Appendix G

Supplemental Biological Resources Report

**SUPPLEMENTAL BIOLOGICAL RESOURCES REPORT
FOR THE
LOS ANGELES AERIAL RAPID TRANSIT PROJECT
LOS ANGELES, CALIFORNIA**

September 2023

Figure 4-1. Areas of Woodland Habitat Proposed for Removal within BSA, in Relation to Similar Habitat in Surrounding Area

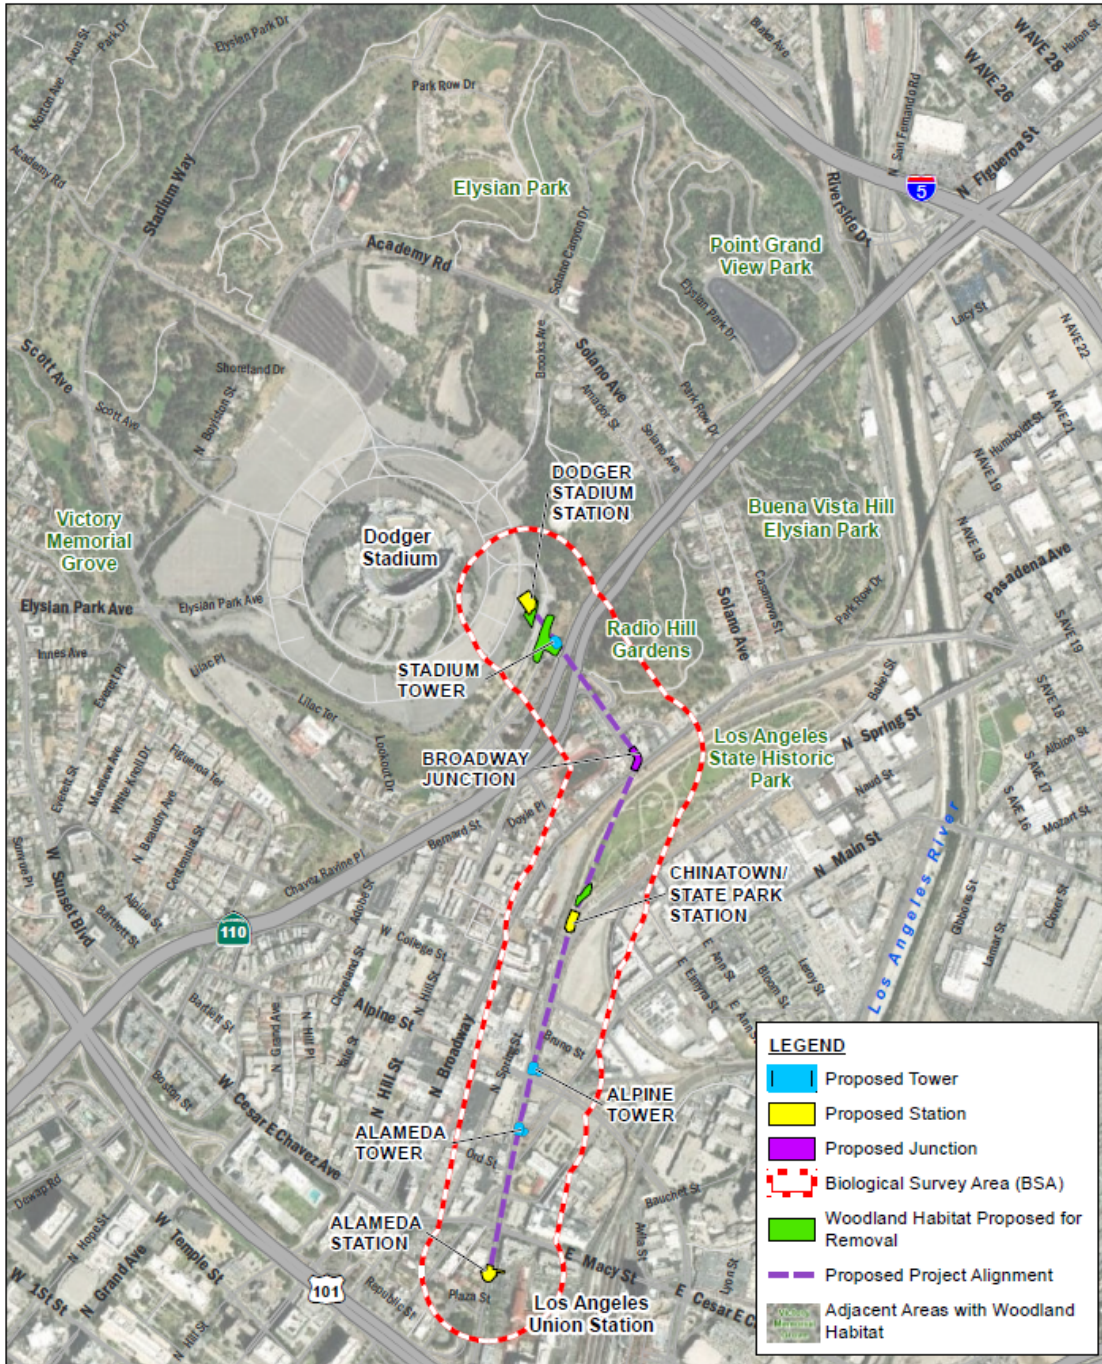
As discussed in Section 3.4.2, Environmental Setting, of the Draft EIR, there are no sensitive natural communities such as wetlands, oak woodlands, or coastal sage scrub habitat in the BSA. There are no wildlife corridors in the BSA to support movement of wildlife species. There are no Habitat Conservation Plans that overlap with the BSA, and the nearest Significant Ecological Area is approximately 5 miles north-northwest of Dodger Stadium at Griffith Park. As discussed in Section 3.4.3, Methodology, of the Draft EIR, a proposed project would only have a significant impact on biological resources if it would “have a substantial adverse effect, either directly or through habitat modifications, on any species identified as candidate, sensitive, or special status species.” An overview of tree removal in areas that could be considered wooded habitat for common species is provided for informational purposes, below.

The only areas of tree removal that could be potentially described as wooded habitat are the following: the small grove of Fremont cottonwood trees at the western end of the Los Angeles State Historic Park, the non-native woodland at the Stadium Tower and associated fire buffer, and the non-native woodland at the Dodger Stadium Station location. The total area of wooded

habitat that would be removed in each of these areas is 0.24, 1.02, and 0.39 acres, respectively. These areas are relatively small amounts of wooded habitat, compared to the amounts available in the immediately surrounding areas, such as Elysian Park (approximately 600 acres alone, much of which is wooded), Radio Hill Gardens, Victory Memorial Grove, and Point Grand View Park (Figure 4-1).
